WRITTEN STATEMENTS

19 October 2021

**Planning and Amenity Delegated
Committee Meeting**

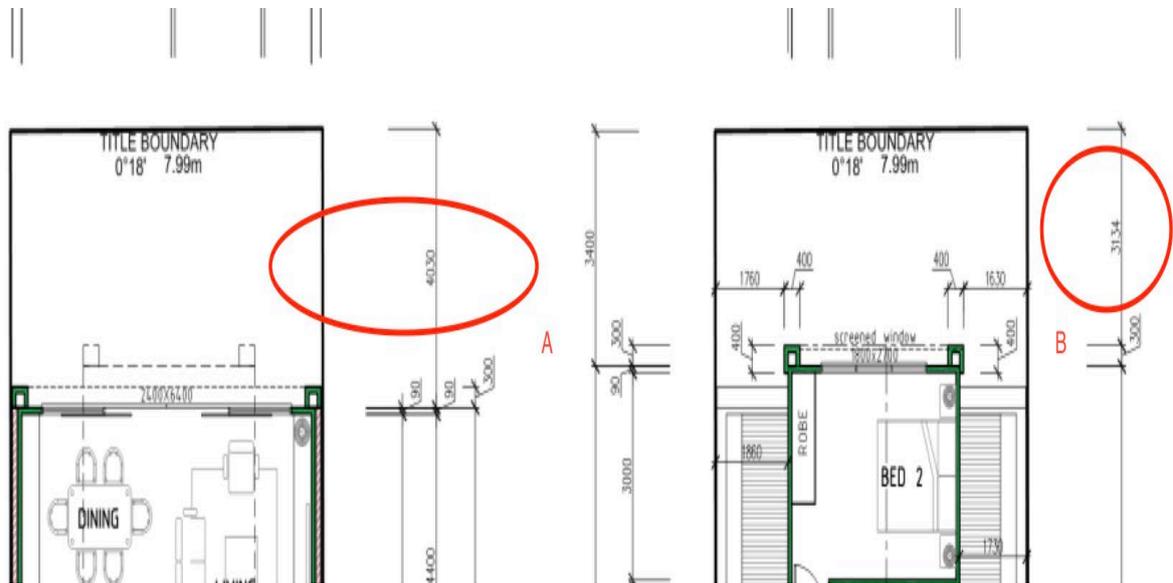
The required setback from the Rear boundary (West) is 5.98m whereas the **proposed plans show 3.1m** – please see the diagram below which shows the measurement from the boundary to the facade of the second storey structure.

*Please note that the Officers report incorrectly shows a setback of 3.4 as it has assumed the screened window is attached to the outside the building whereas the plans and image below clearly depicts the building itself is in fact 3.1 metres from the boundary.

One factor driving this is that the proposed **first storey overhangs the ground floor** by 896cms (being 4030cms being distance from boundary on the ground floor (A) versus 3134cms being distance from boundary on the first floor (B)).

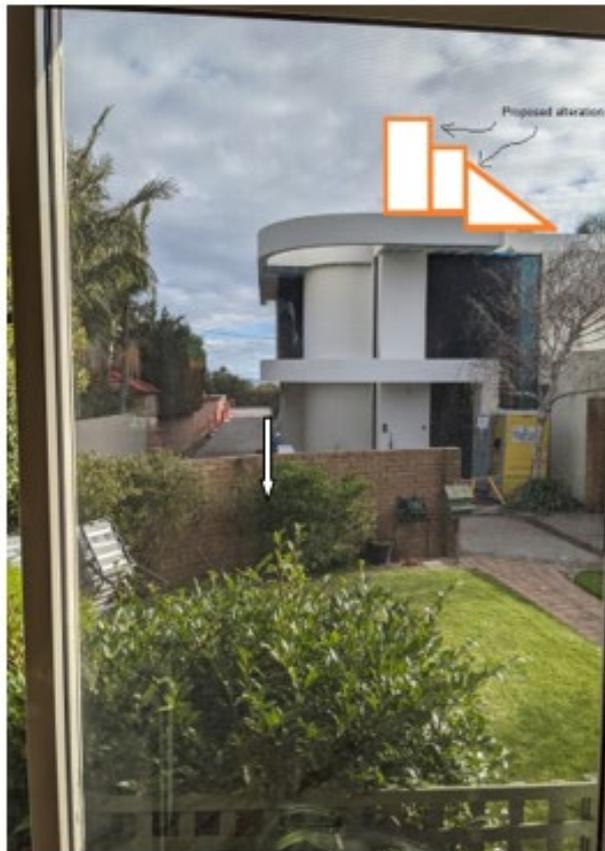
The current Roof Top Plan TP.002 p.191 of 399 shows a clear contrast to the bulk of the combined access structure in the proposed Roof Deck Plan TP1.03 p.176 of 399.

The stair access does not need an access structure so the impact of visual bulk is minimised and softened by the addition of 6 pot plants and the use of clear glass balustrades. Stair climbers step right onto the roof deck.

In contrast again, the plan TP1.03 shows what looks like a BBQ etc in lieu of the pot plants.
